World Forum for Harmonization of Vehicle Regulations

Motorcycle braking – Global Technical Regulation No. 3

Proposal for amendments to Global Technical Regulation No. 3 (Motorcycle brake systems)

Submitted by the representative from Italy*

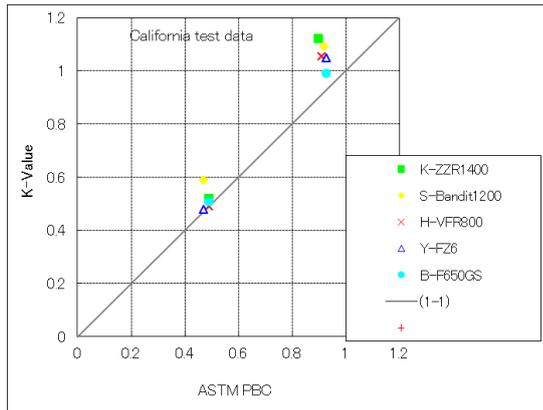
(c) During GTR3 discussion, correlation test between K-method and ASTM method had been done in California. The data from the test are shown in the below graph.

PBC values by K-method were for same course, and the following were recognized.

- PBC values were different by measuring motorcycle (tyre).
- Such level of difference should be permitted.

It was recognized that even for the same course PBC values were different for each motorcycle. It was noted that it is beneficial to measure the PBC values of the course using the same motorcycle to maintain the course PBC value condition.

The IMMA proposal includes a condition saying that when choosing the motorcycle, correlation level of the motorcycle for K-method to ASTM method should be confirmed. IMMA believes that the motorcycle with correlation level the same level as California test result can be a representative vehicle to be used for measuring PBC values of the course.

Note: A representative vehicle may be acceptable for PBC measurement by method (b) if that vehicle has shown the same nominal PBC on both high μ and low μ as previously determined by method (a).

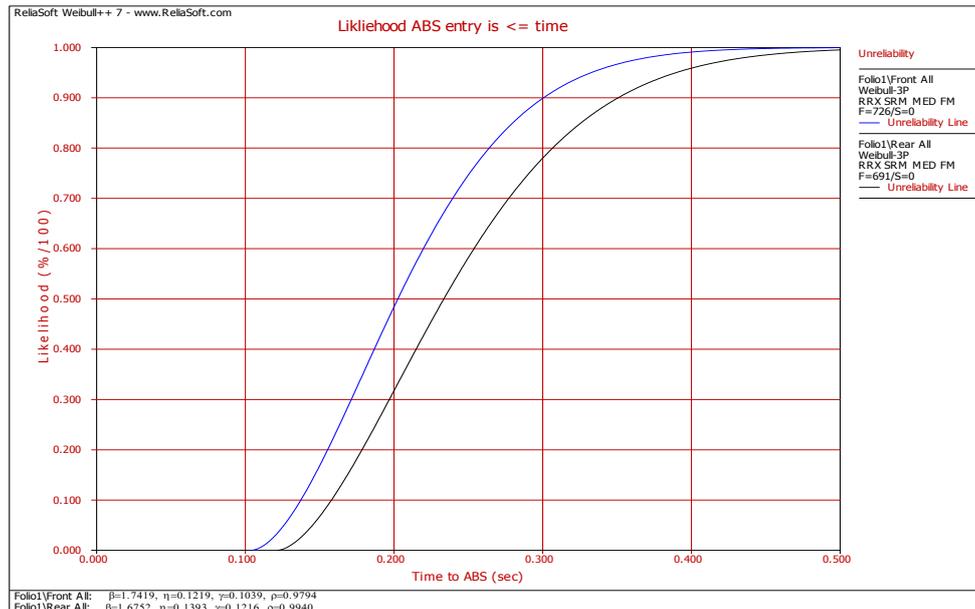
It has been noticed in testing that the brake application rate specified in section 4.9.5.1 can result in a large number of test failures. It can be seen in the chart below that the 0.2 second lower limit shows a failure rate is between 30% and 50% of the time.

By reducing the lower limit to 0.1 seconds the test failure rate reduces to practically zero. Allowing the reduction tends to make the regulation more stringent by including a greater number of brake force application rates and eliminates restrictive test requirements.

The brake control actuation force is applied in **0.1 – 0.5** seconds."
